# THE VILLAS AT CLAREMONT RANCH

## CONSTRUCTION DRAWINGS

### STREET IMPROVEMENTS PLANS

## STORM SEWER PLANS

**THE VILLAS AT CLAREMONT RANCH**  
**SIGNAGE & STRIPING PLAN**

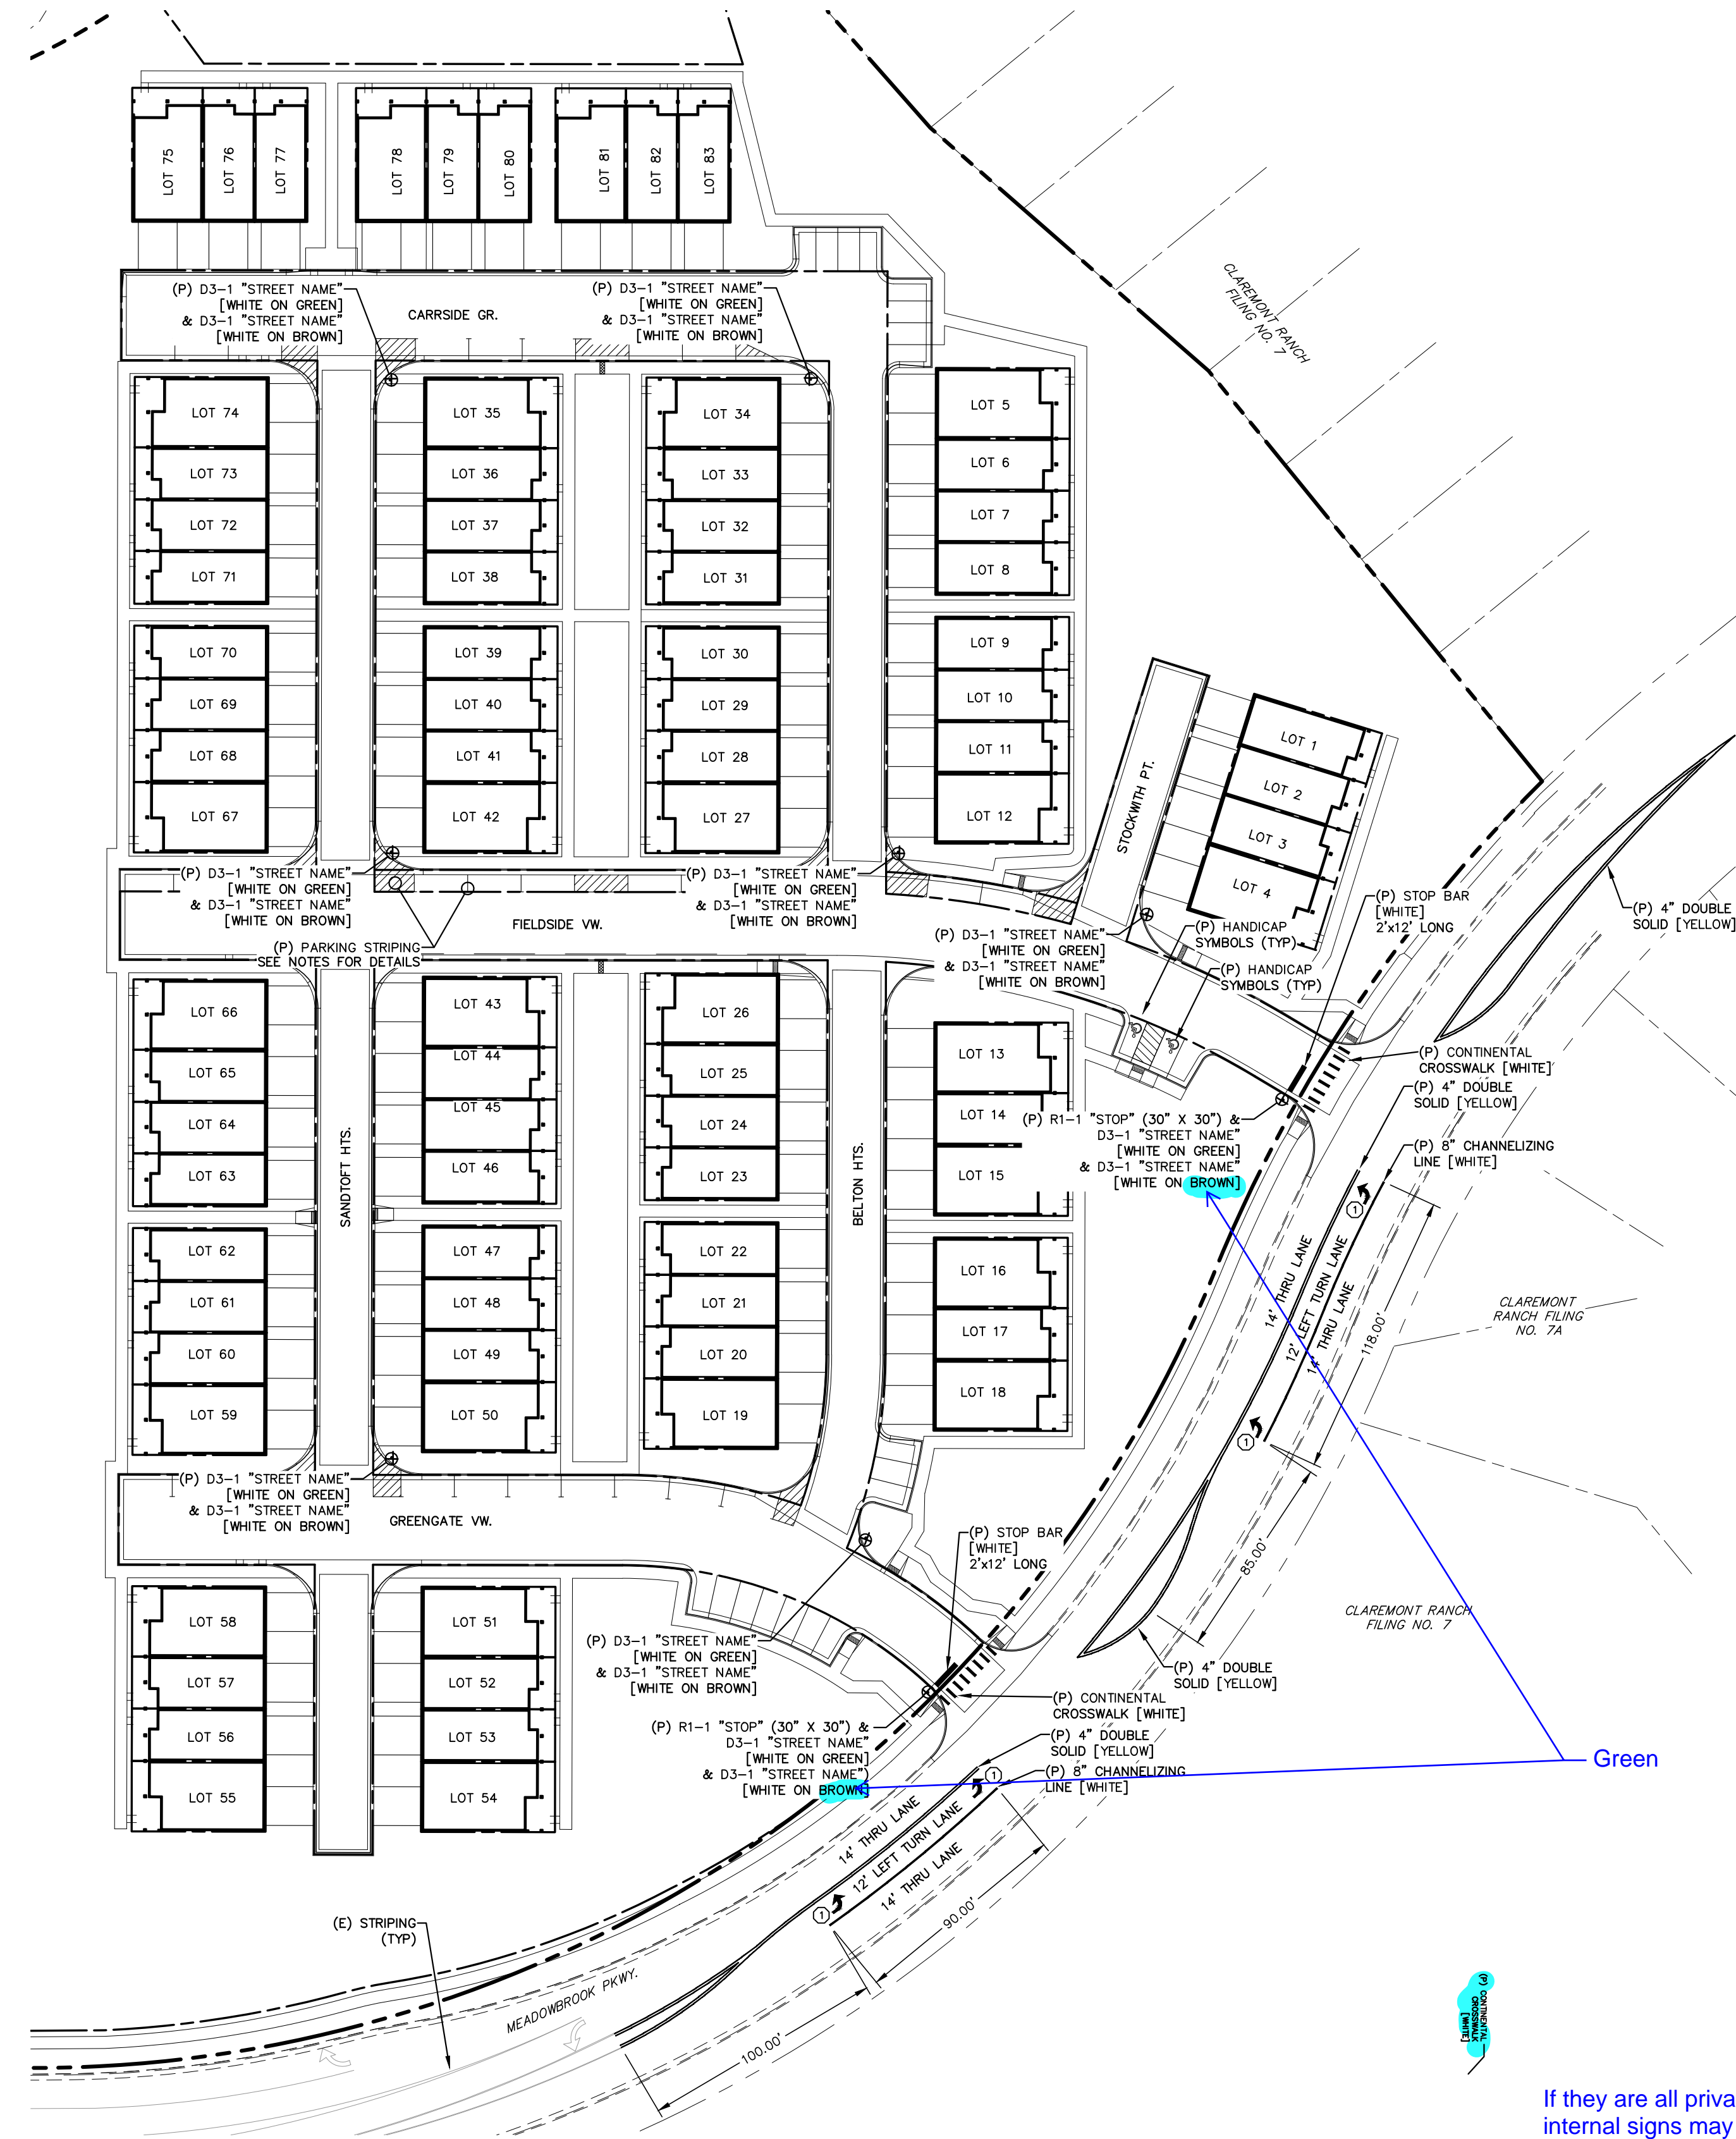
If they are all private the internal signs may be brown, but the ones on Meadowbrook need to be green per County standard.

THE VILLAS AT CLAREMONT RANCH  
 STORM SEWER PLAN & PROFILES

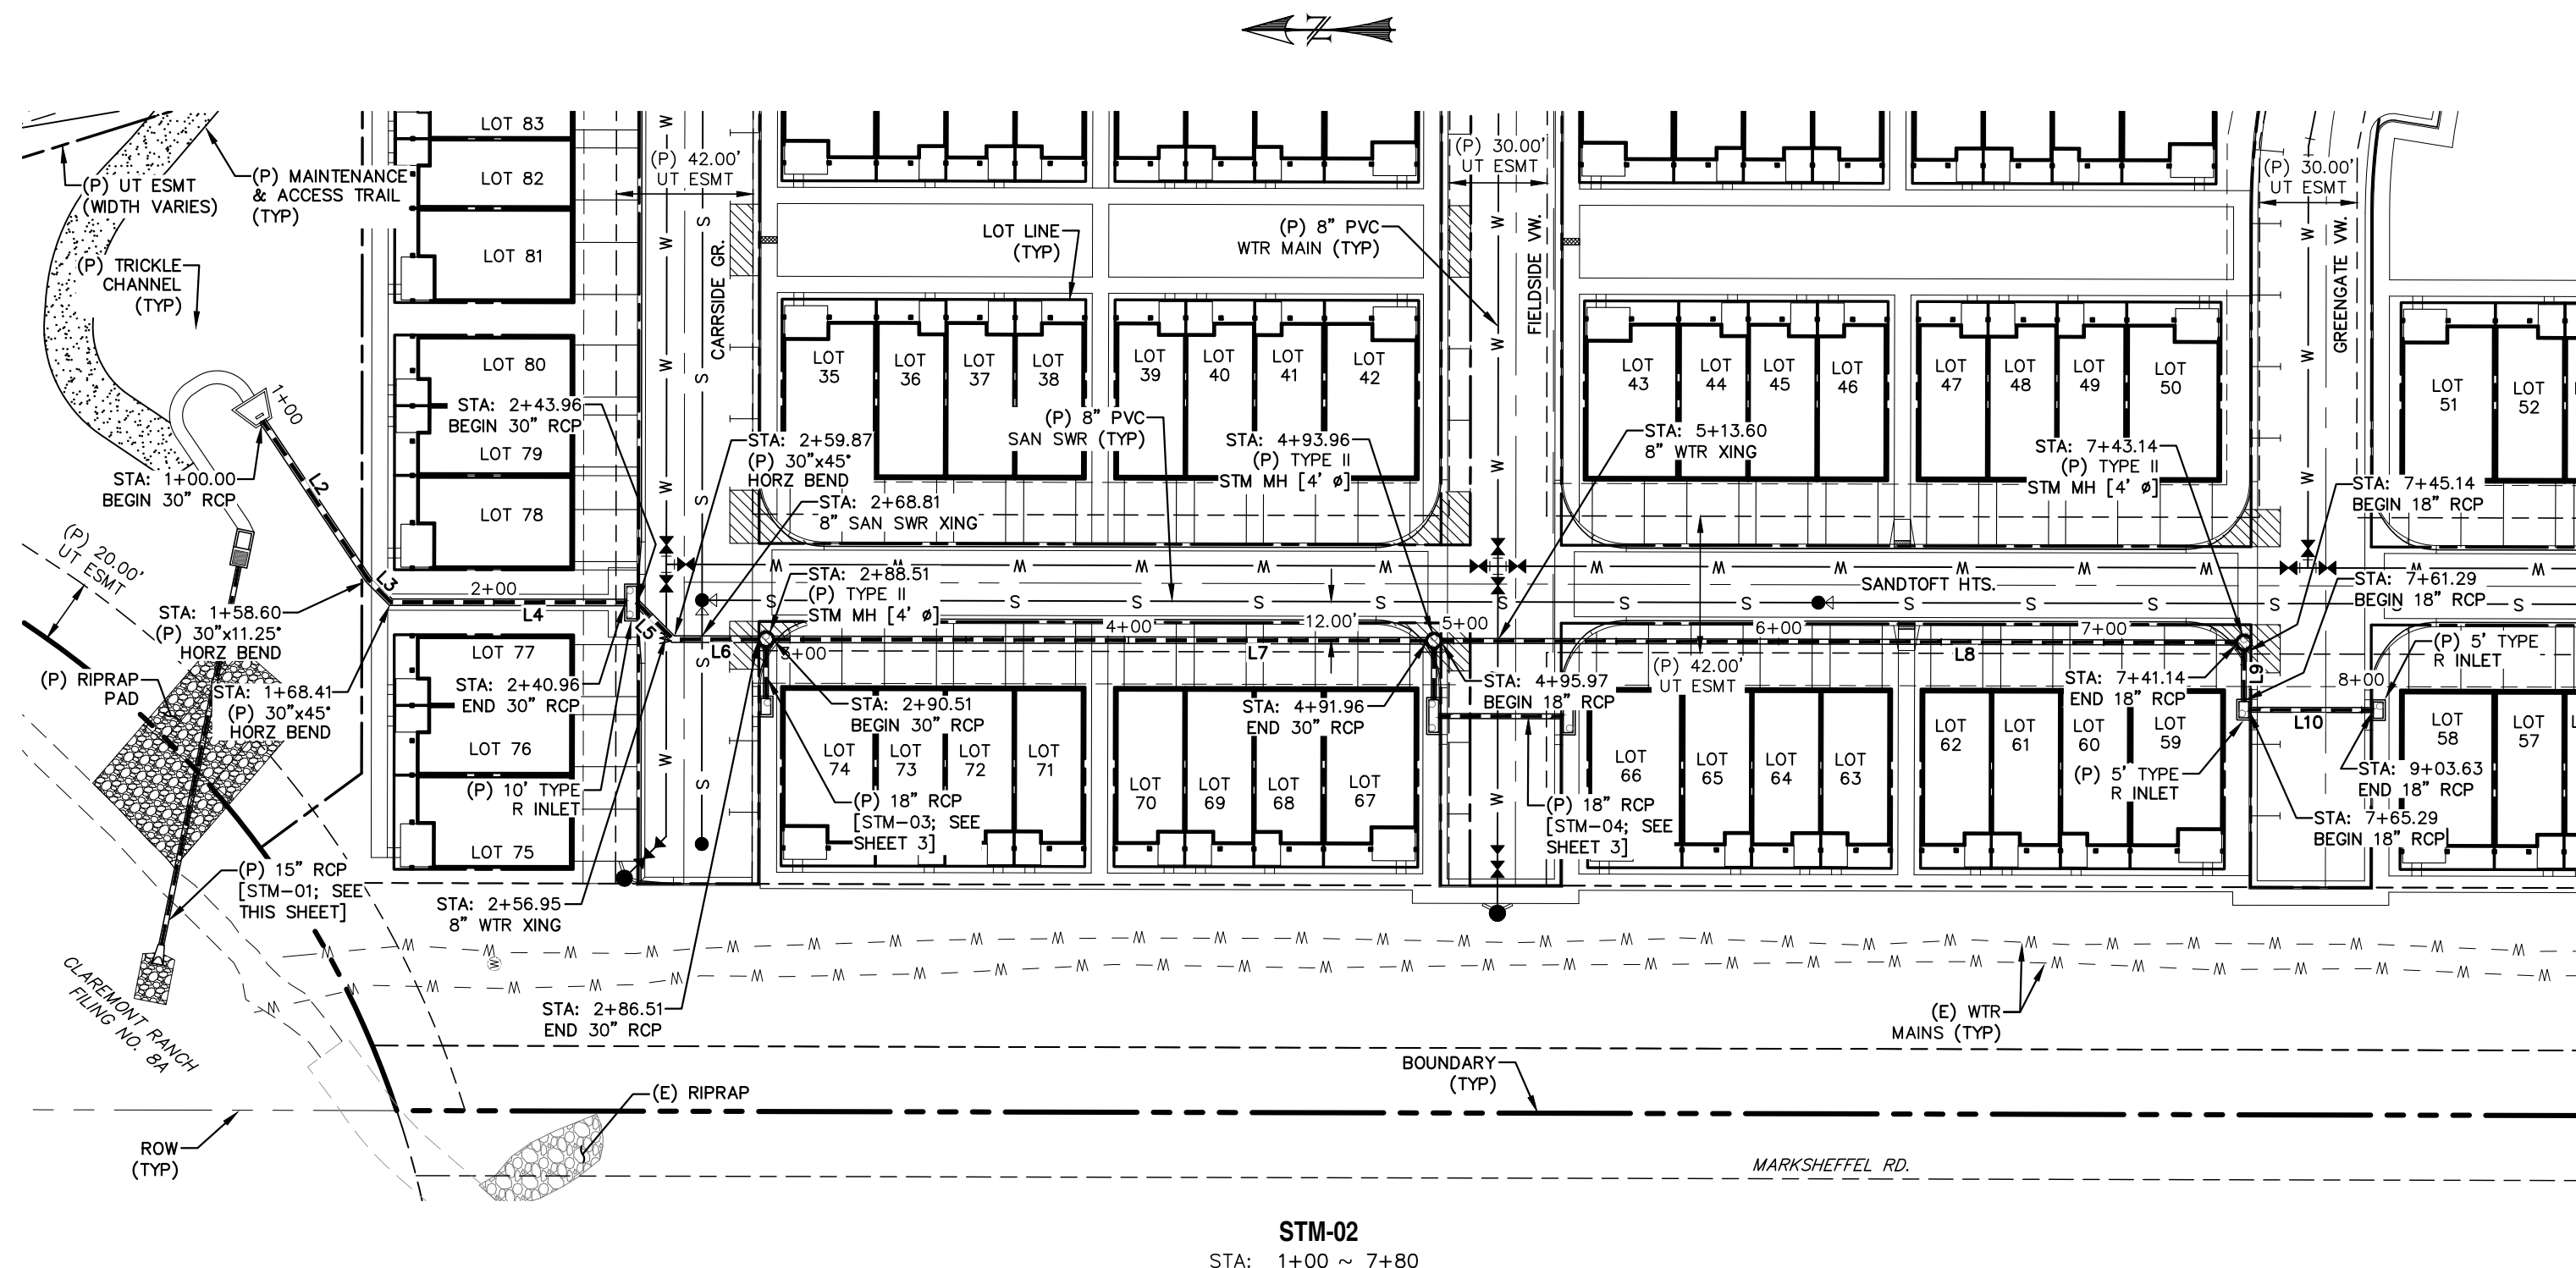
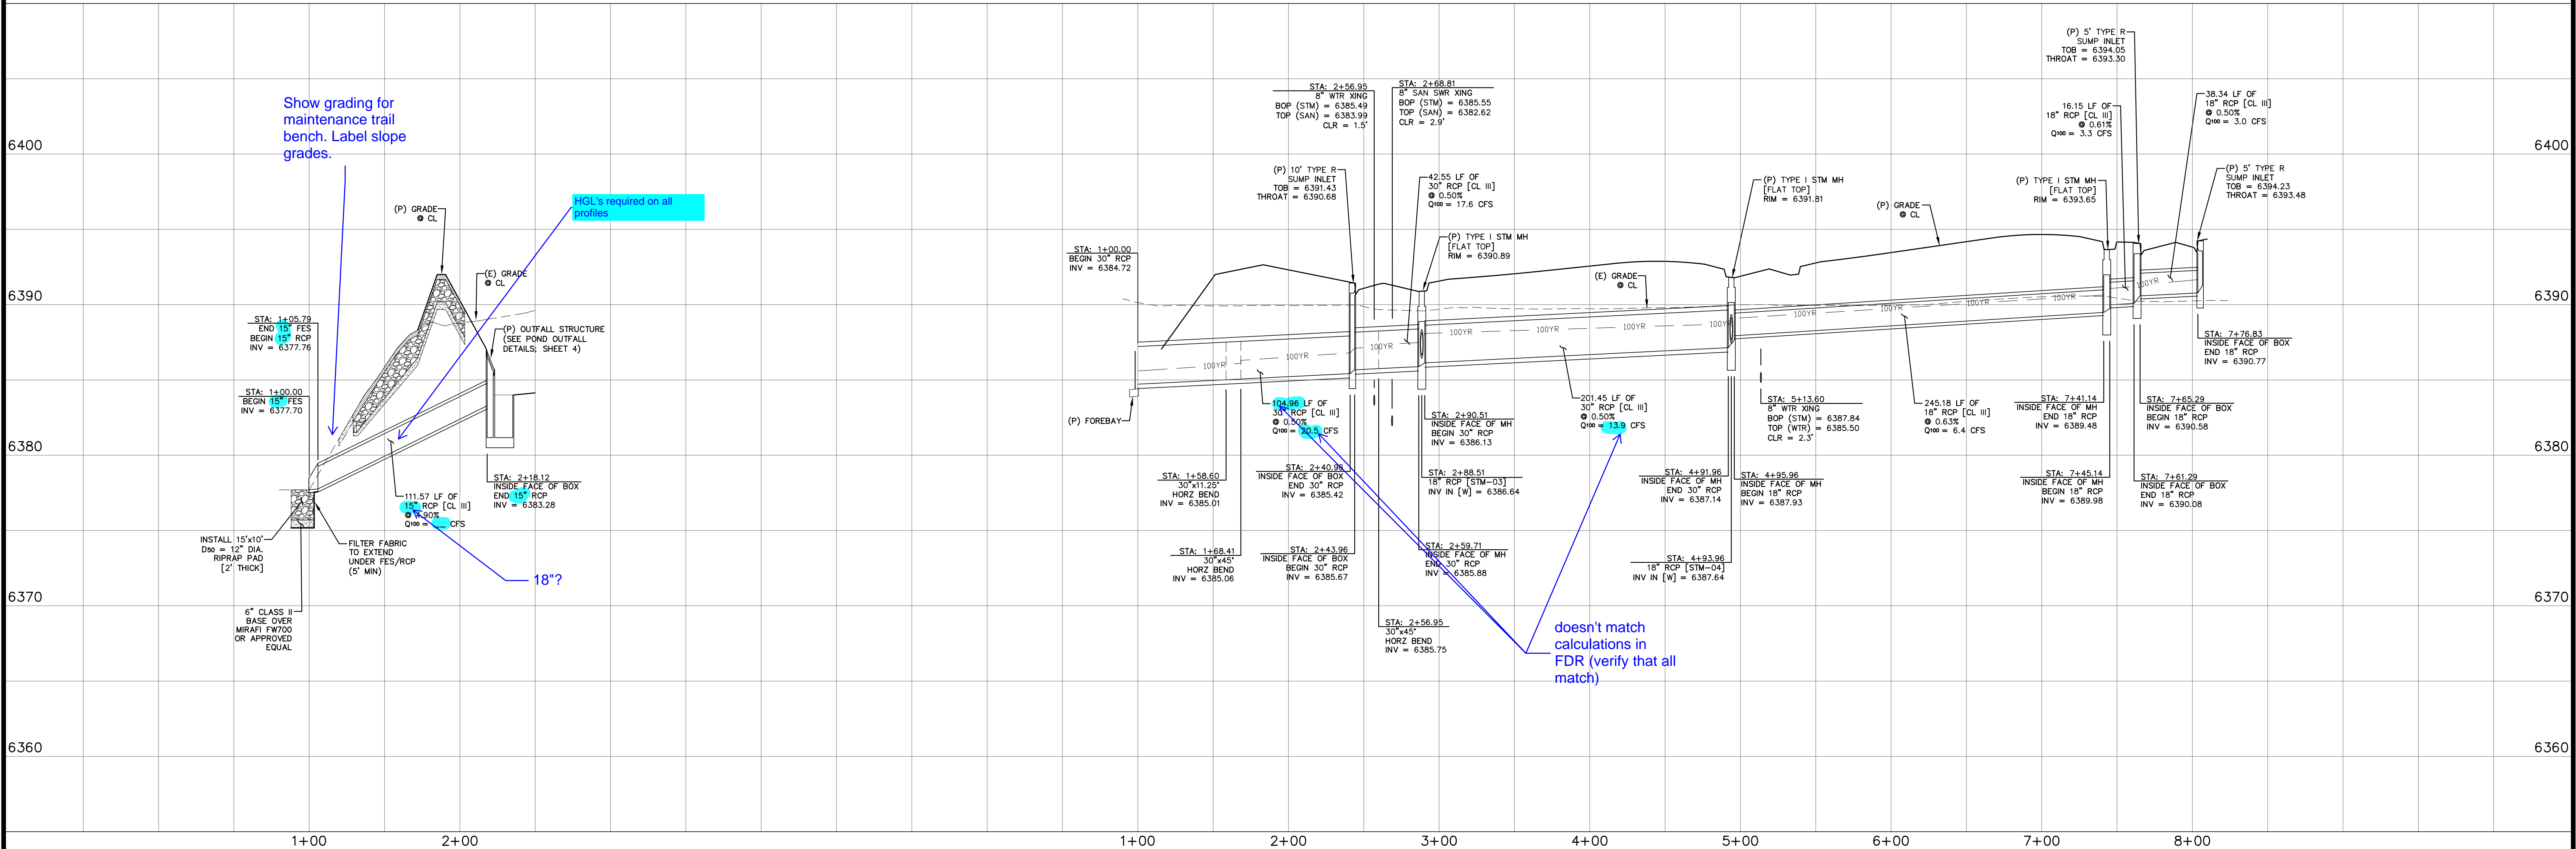
Show grading for maintenance trail bench. Label slope grades.

HGL's required on all profiles

doesn't match calculations in FDR (verify that all match)
